NEW LIBRARY
LEARNING
RESOURCE
CENTER BUILDING

**LANDSCAPE SITE
LAYOUT PLAN**

1 1ST FLOOR OVERALL PLAN - ELECTRICAL
NO SCALE

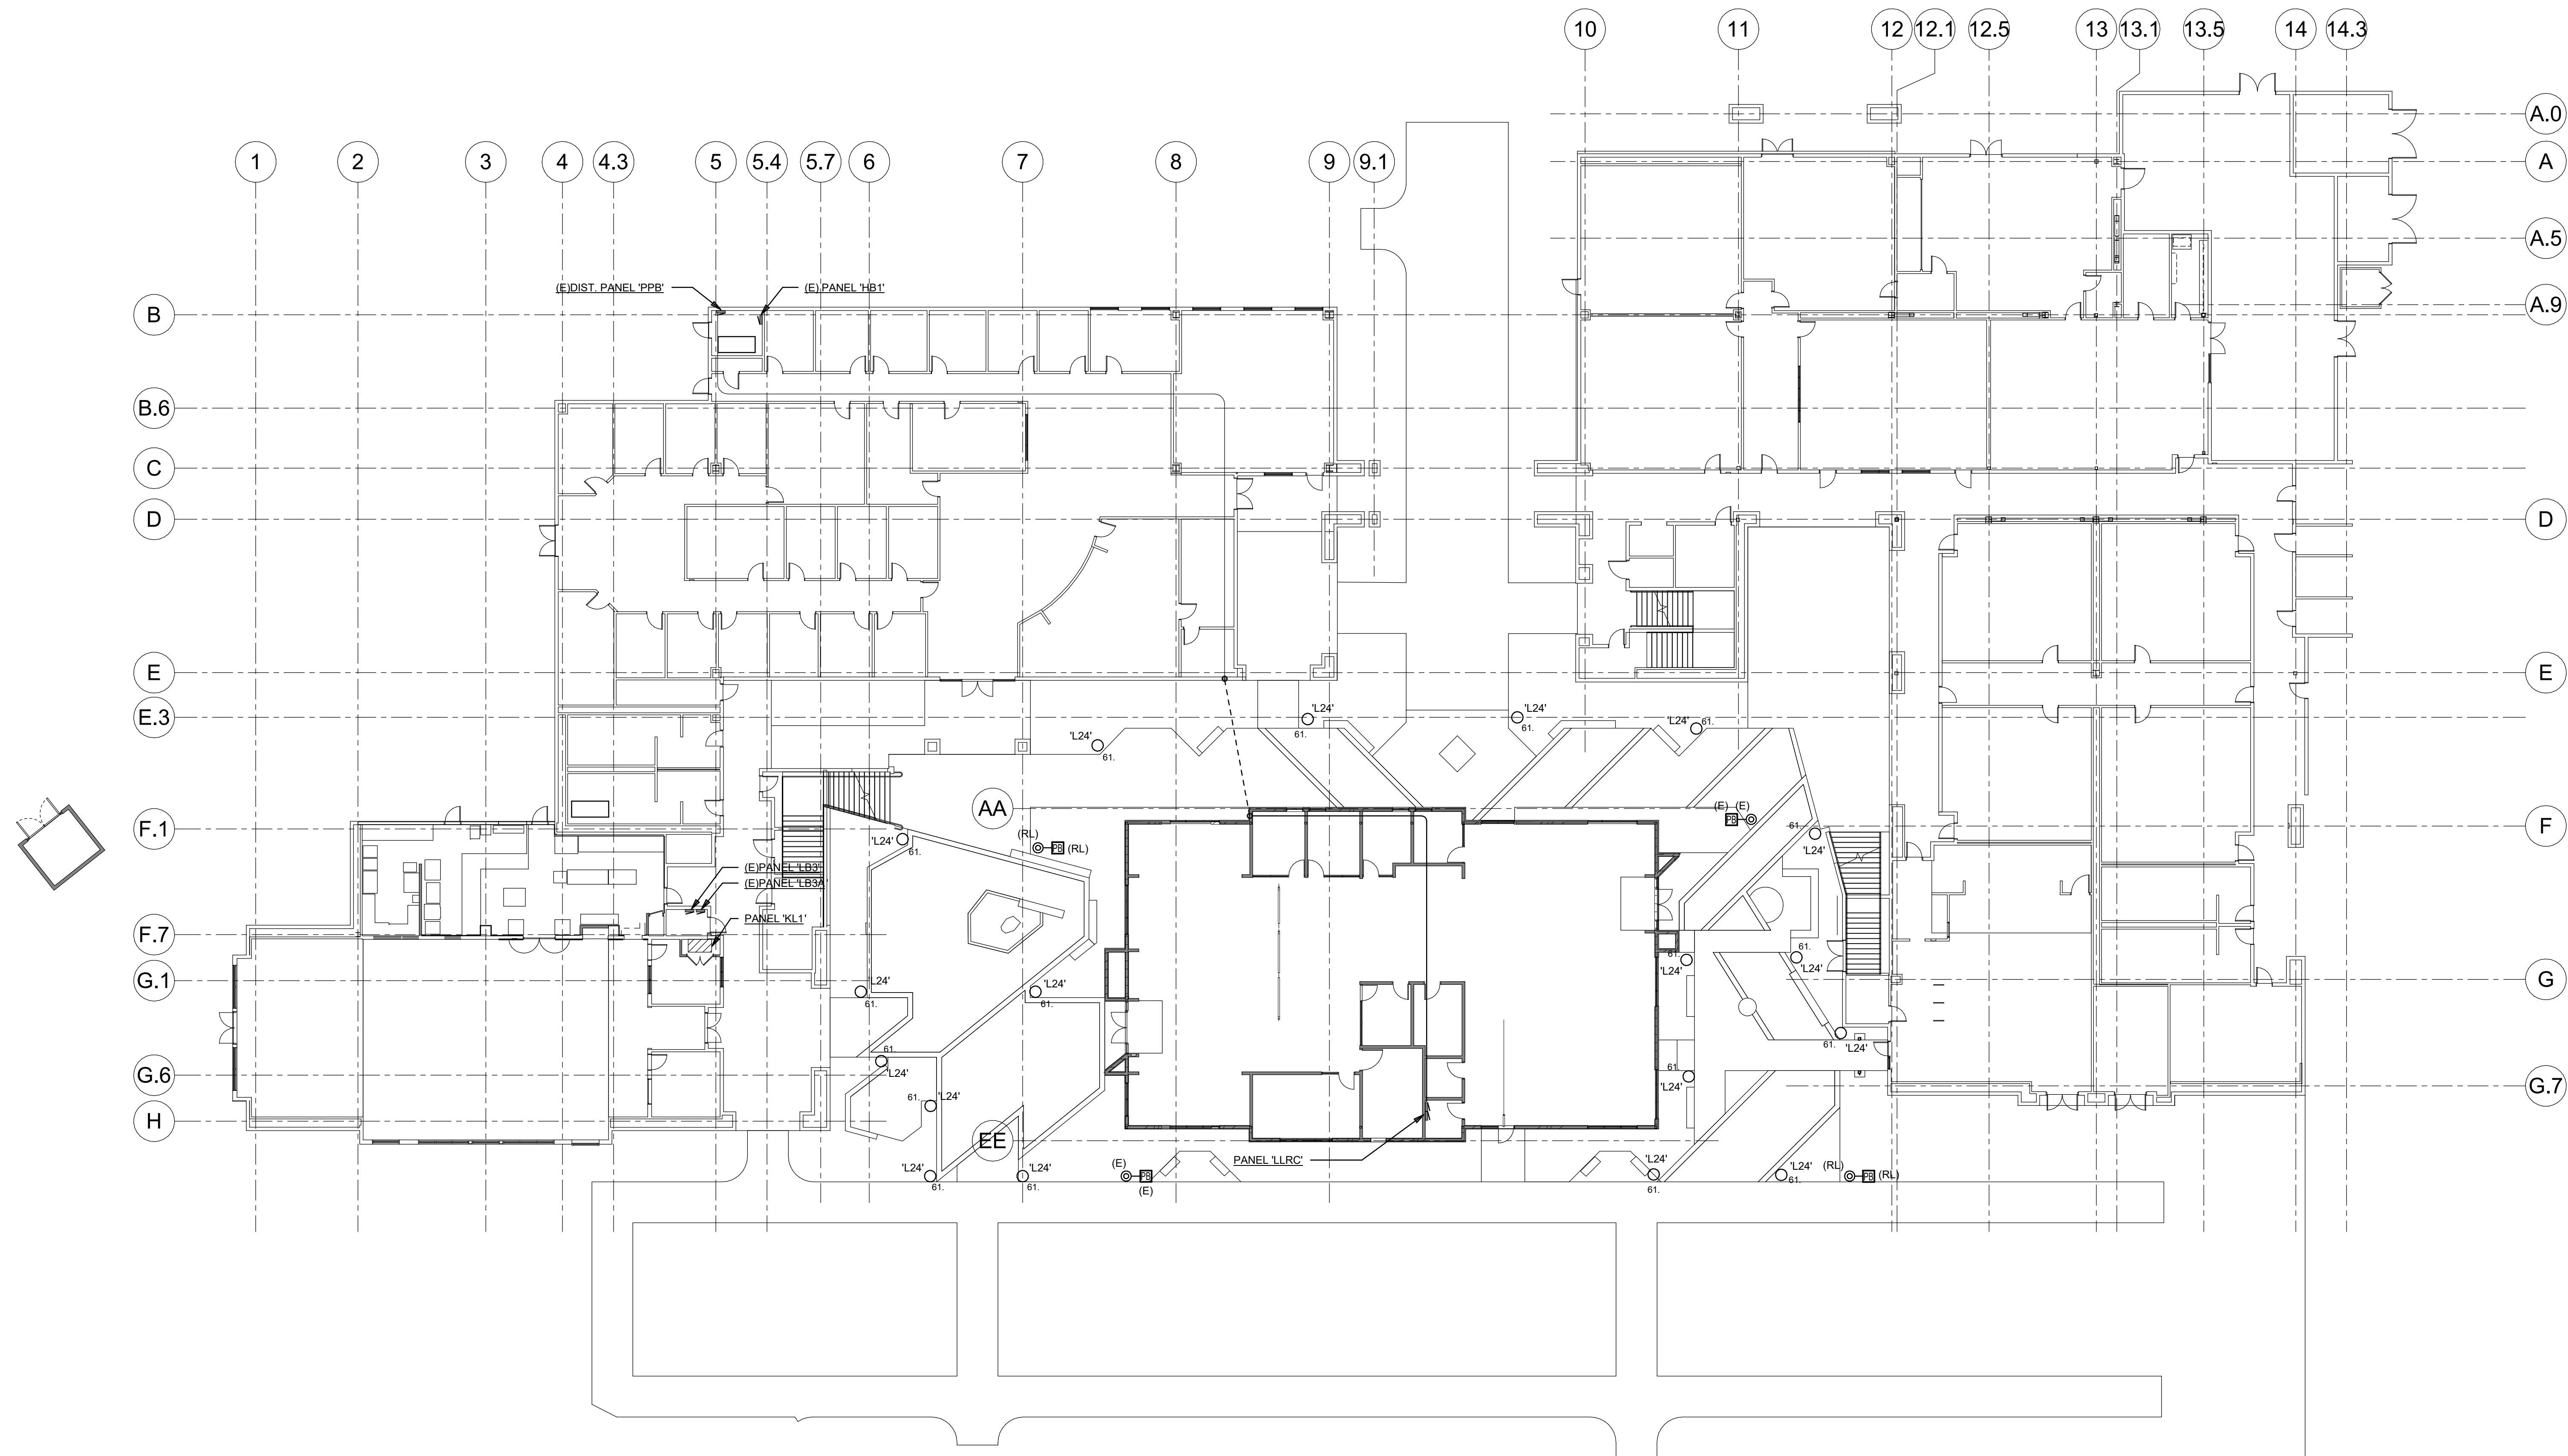
RFI #185 - MEI LINK BRIDGE AND LIGHTING CONTROL IN LLRC
Bridge 4 will be connected to the Eclipse System Controller located in the same building (learning commons / cafe). Bridge 1, 2, & 3 will be connected to a 2nd Eclipse System Controller located in the LLRC building. Both system will work independently from each other, but will need to be configured separately. Verify with campus if the two system are to be connected together, if yes, there are two options to do this. See markups in attached lighting control diagram from submittal 260300-1.2 dated 02/20/2020. Provide shop drawings back to vendor for corrections on diagram to reflect two buildings instead of Floor 1 and Floor 2, and update on either options upon coordination with campus.

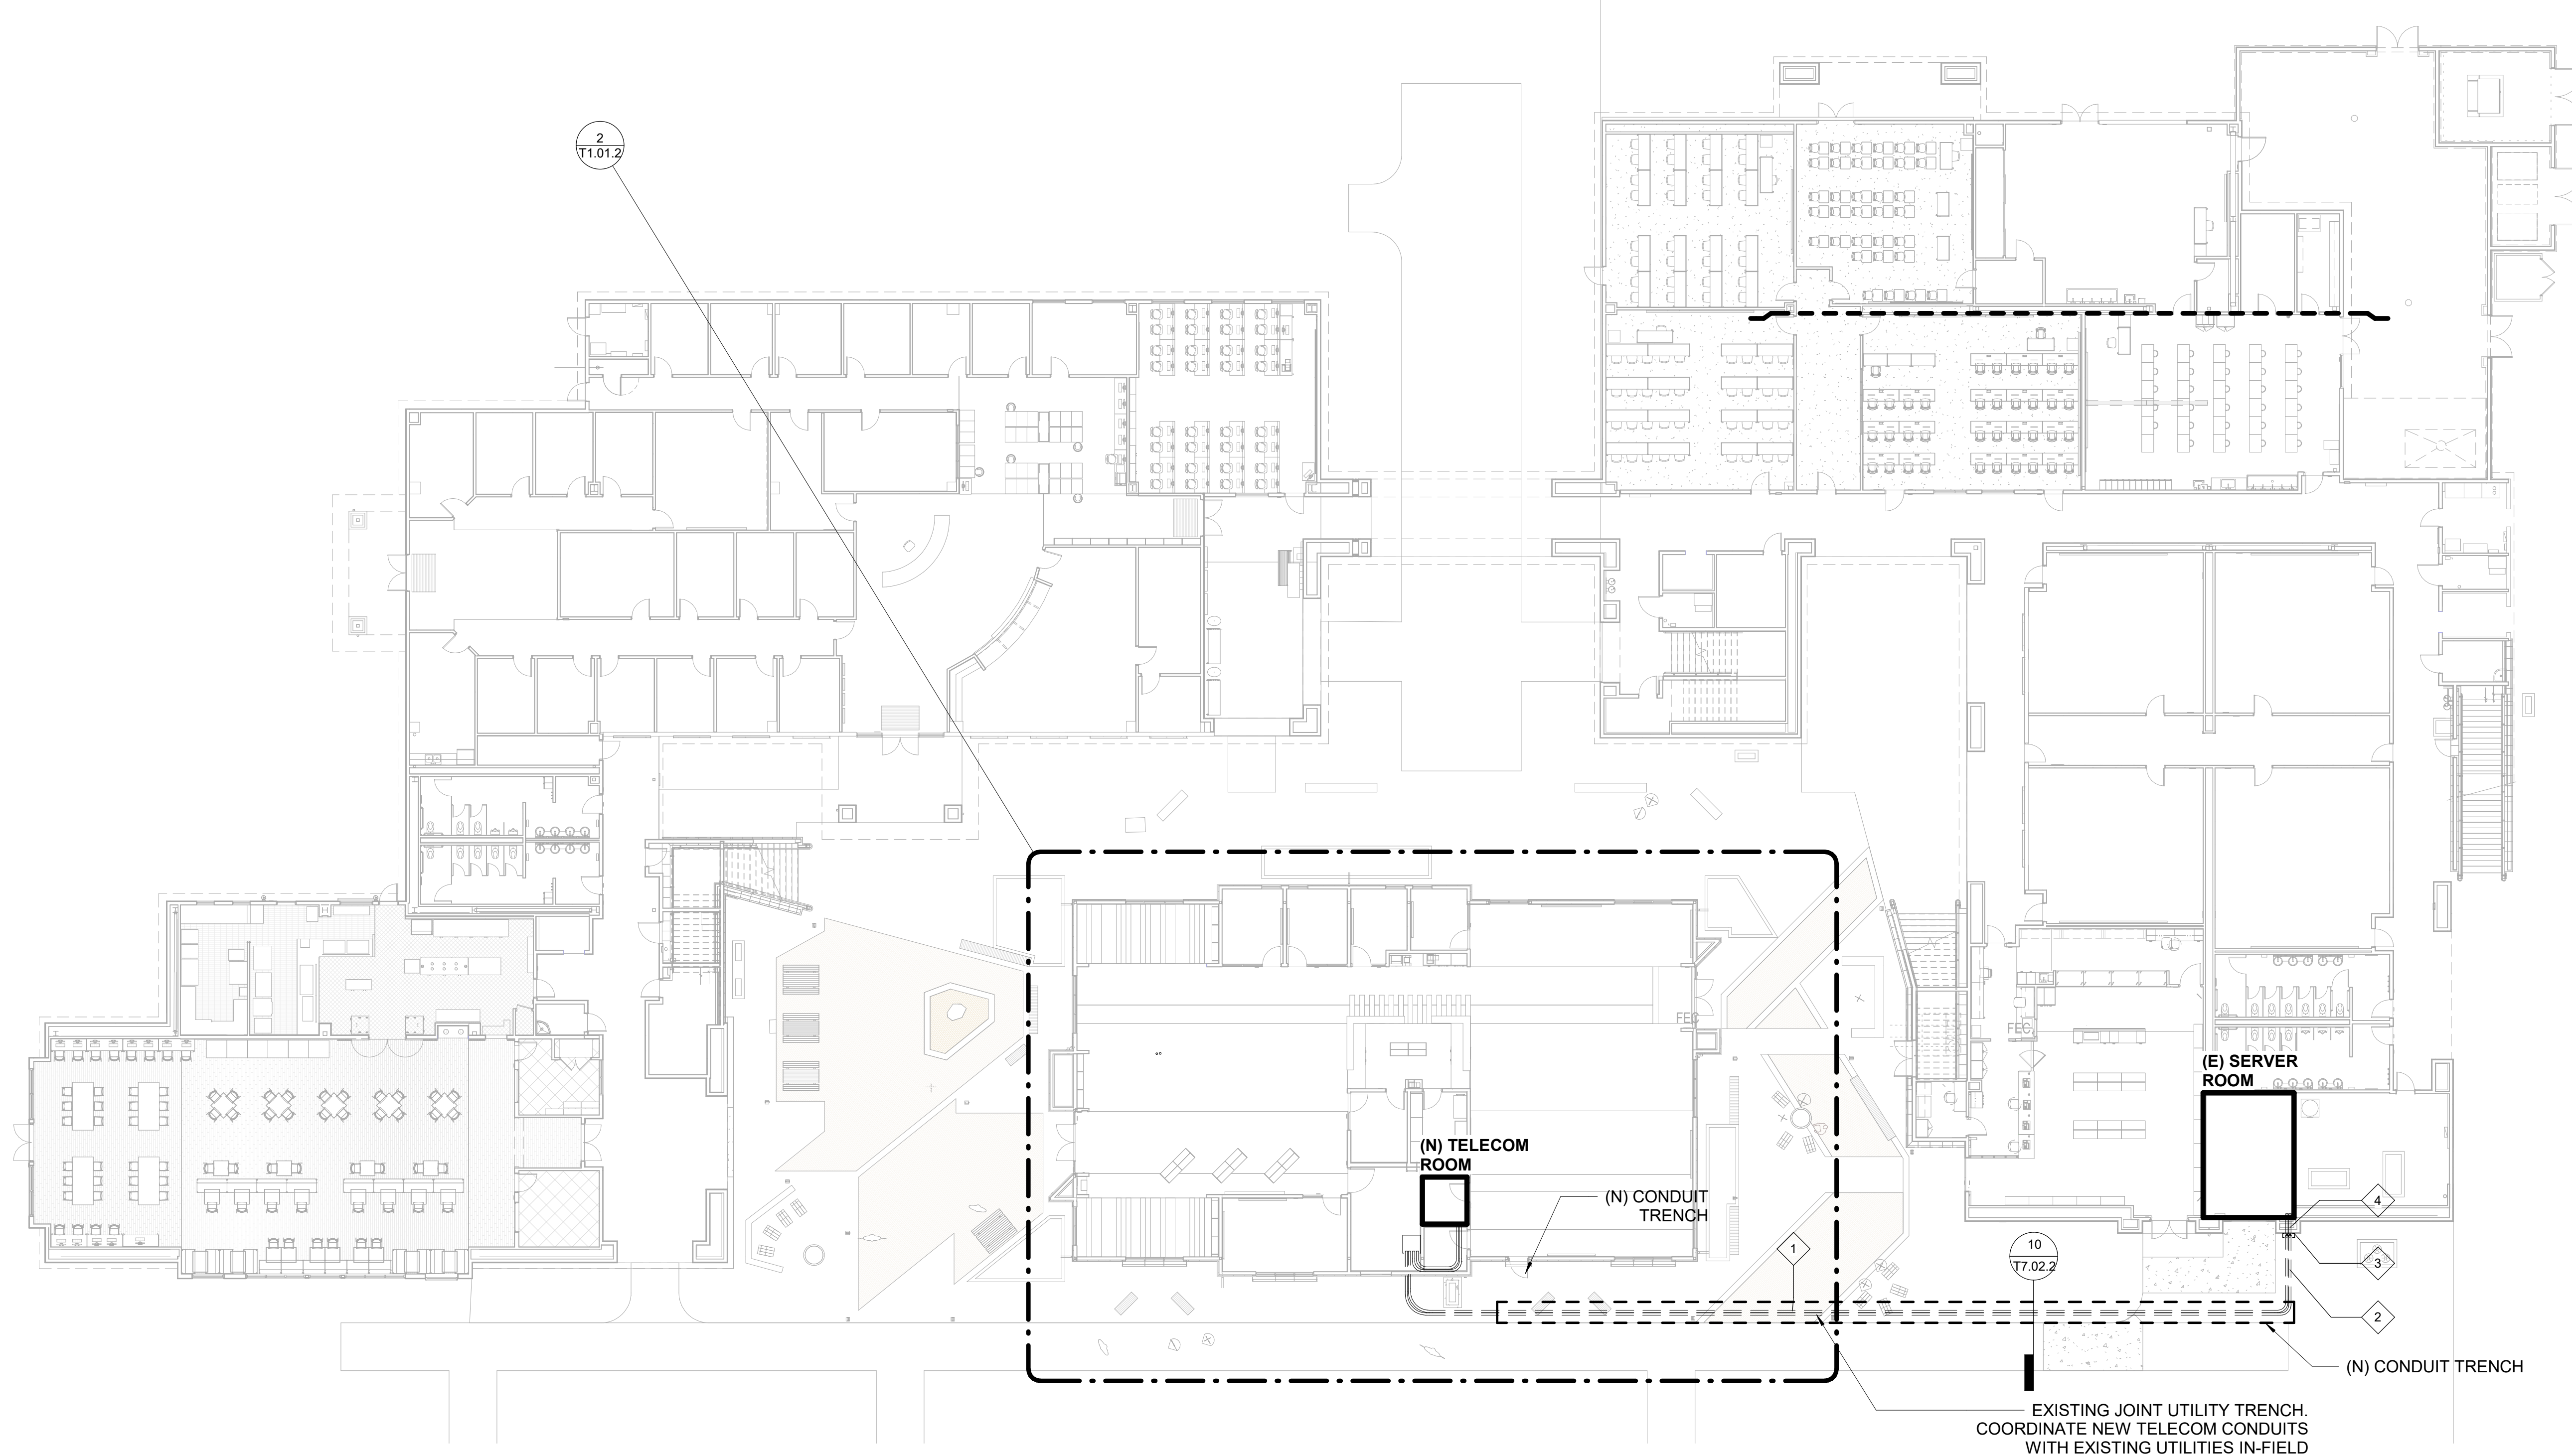
RFI #24 - REVISED PROPOSED MOUNTING AND ROUTING

RFI #200 - REROUTING OF DATA CONDUITS COMING INTO LLRC
